Lotus Elan M100 Service Bulletins
Series 1 and Series 2 1990 - 1996

SERVICE BULLETIN

TITLE: Replacement of headlamp flap 'J' links.

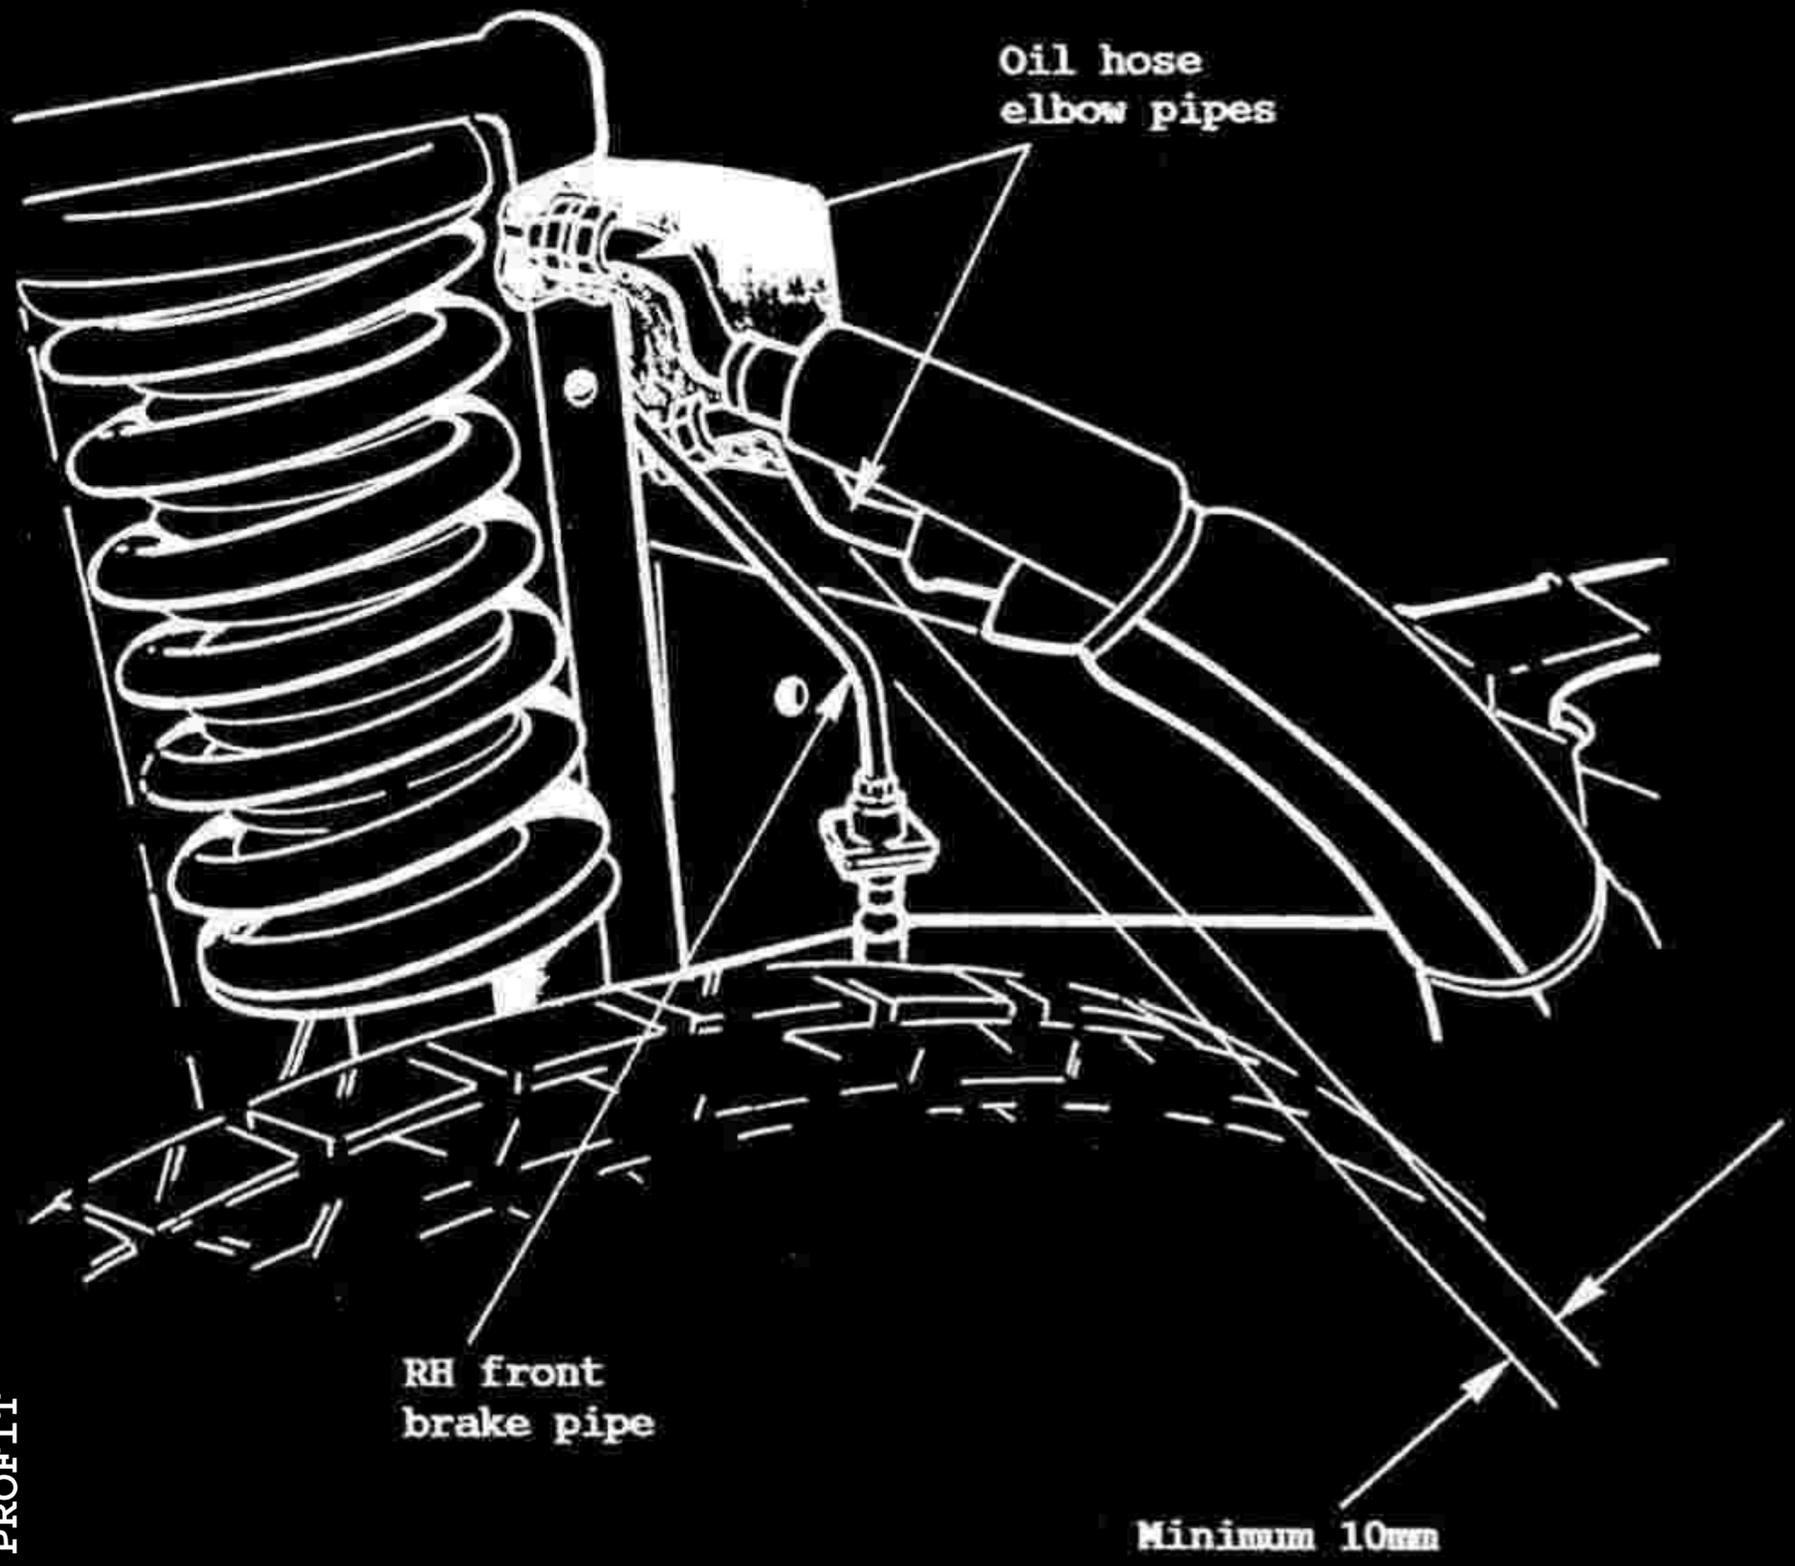
REASON: To ensure adequate clearance is maintained after disturbance of an oil hose connector union. Feed and return connections for the oil cooler are provided at the right hand rear of the engine, adjacent to the RH front suspension turret. The two oil cooler hoses which connect to these unions use short elbow pipes at the engine end to permit their routing between the topshell and longeron. Care must be taken when tightening these joints to achieve the correct elbow pipe orientation and provide sufficient clearance between the elbow pipes and the adjacent brake pipe, allowing for the full range of engine movement on its rubber mountings.

1. Remove the RHF wheelarch liner.
2. Carefully examine the elbow unions and brake pipe for signs of chafing or damage, using a mirror if necessary, and renew components if necessary.
3. Check for oil hose elbow pipe clearance as shown in the illustration. There should be a minimum gap of 10mm between both the elbows and:
 - the brake pipe;
 - the chassis longeron;
 - the body topshell.
 If necessary, slacken the elbow pipe union nut and reposition the elbow, and/or bend the brake pipe to achieve the specified condition. Torque tighten the union nuts to 27 Nm (20 lbf.ft).
4. Refit the wheelarch liner.

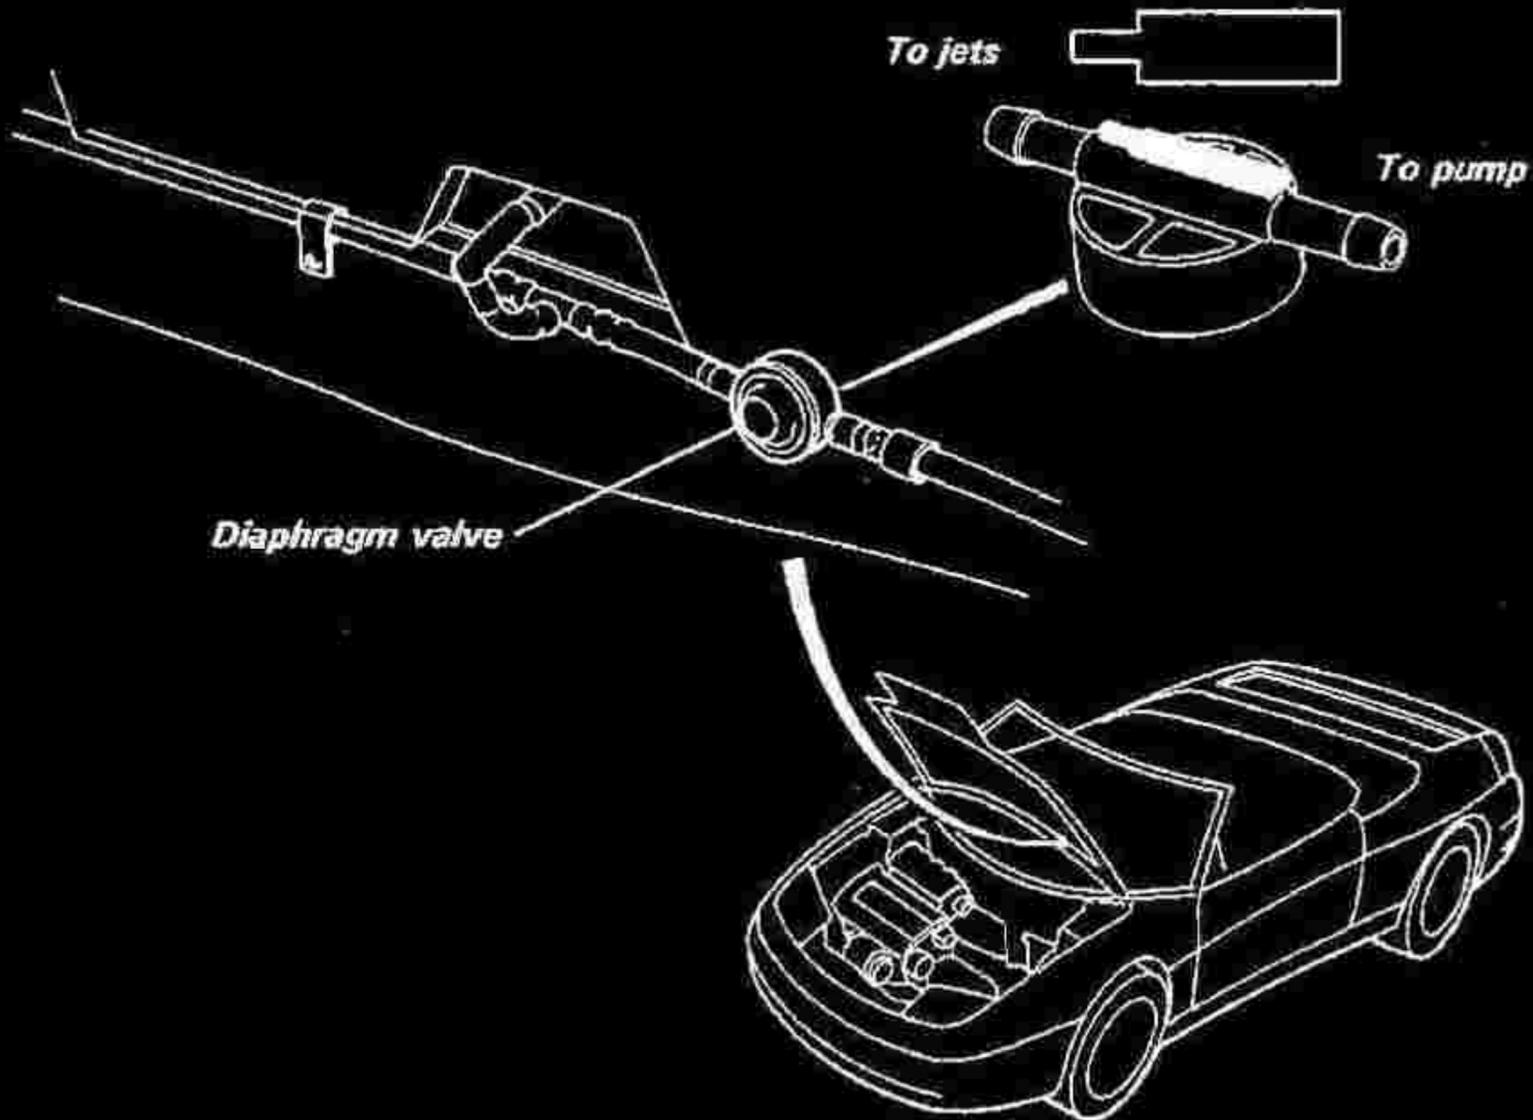
REASON: To prevent 'dribbling' from washer jets.
A spring loaded diaphragm valve is fitted in the windscreen washer tubing in order to close off the pipeline unless pressurised by the pump. This device is designed to prevent self-siphoning and dribbling from the washer jets. On early cars, the valve is located next to the washer bottle in the boot, but the inertia of the water column between the valve and jets can, under hard braking or cornering, result in sprinkling from the jets.

ACTION: If a customer expresses concern about the trait described above, the diaphragm valve should be relocated to a position under the bonnet, immediately before the 'T'-piece junction for the LH washer jet. This site is used on current Elan S2 production.
The preferred plumbing is with the symbol on the underside of the valve oriented as shown below:
